# Work Order ID 90580

Item Name: Crosstube Fwd High

DRAWING NO. D212-664-141	TITLE XTUBE ASSY (205/212/412 HI FWD)	REV. D	DART AEROSPACE LTD ENGINEERING ORDER		D.E.O. NO. D212-664-141-D-1	SHEET NO. SHEET 1 OF 2	SCALE NTS
DRAWN	CHECKED	MFG. APPR.	APPROVED	DE APPR.			
DATE 11.04.07	DATE 11.04.11	DATE 11.04.12	DATE 11/04/12	DATE 11.04.12

**D212-664-141/-141B  
ASSEMBLY DETAIL**

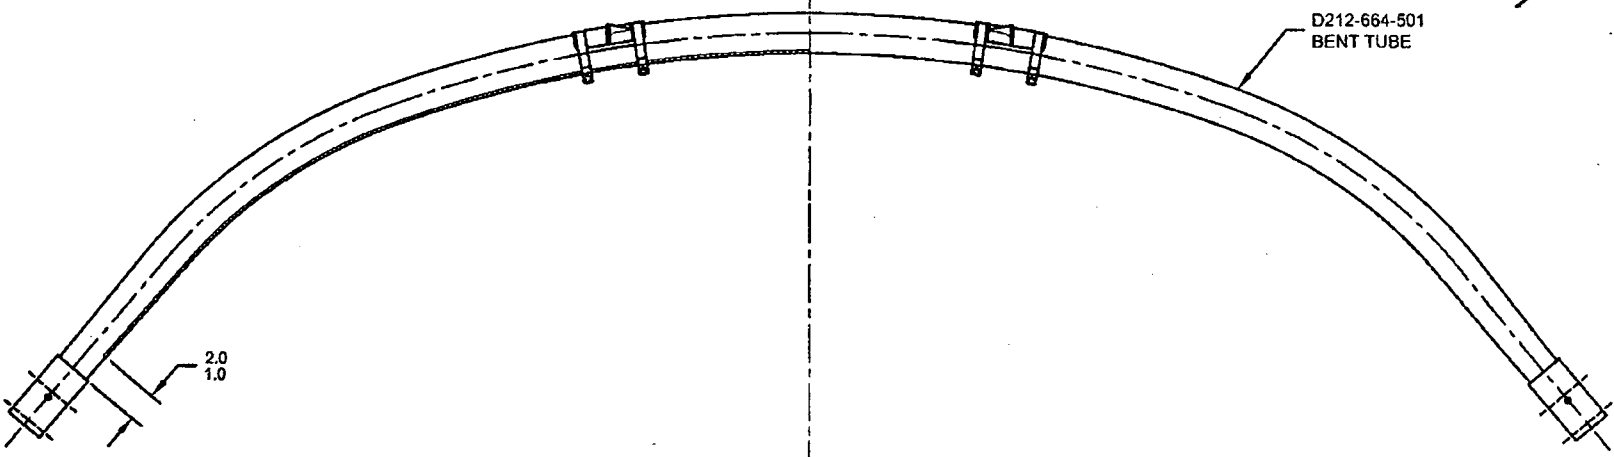
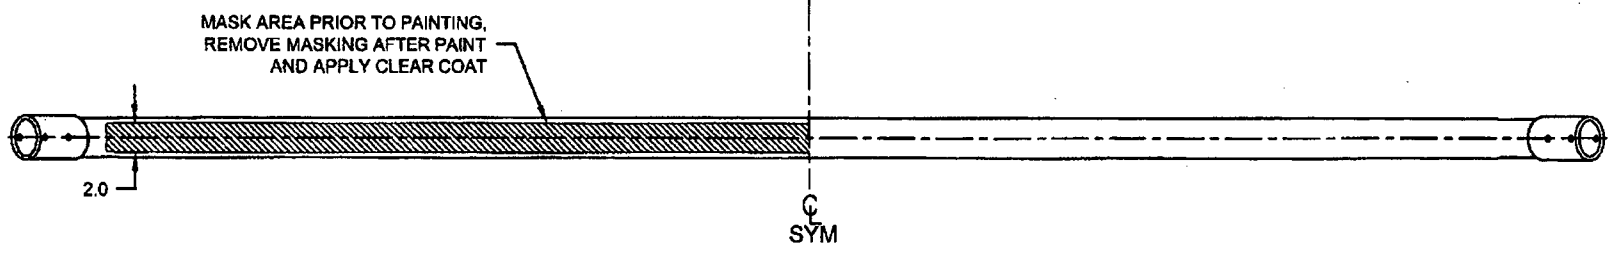
ADD AN INSPECTION WINDOW TO UNDERSIDE OF CROSSTUBE.

NOTES 2 OF SHEET 1 IS AMENDED AS FOLLOWS:

- 2) FINISH: CHEMICAL CONVERSION COAT PER DART QSI 005 4.1  
PRIME INSIDE AND OUTSIDE PER DART QSI 005 4.2  
MASK UNDERSIDE OF CROSSTUBE AS SHOWN (HATCHED AREA) AND  
PAINT OUTSIDE PER DART QSI 005 4.2  
REMOVE MASKING AND APPLY CLEAR COAT
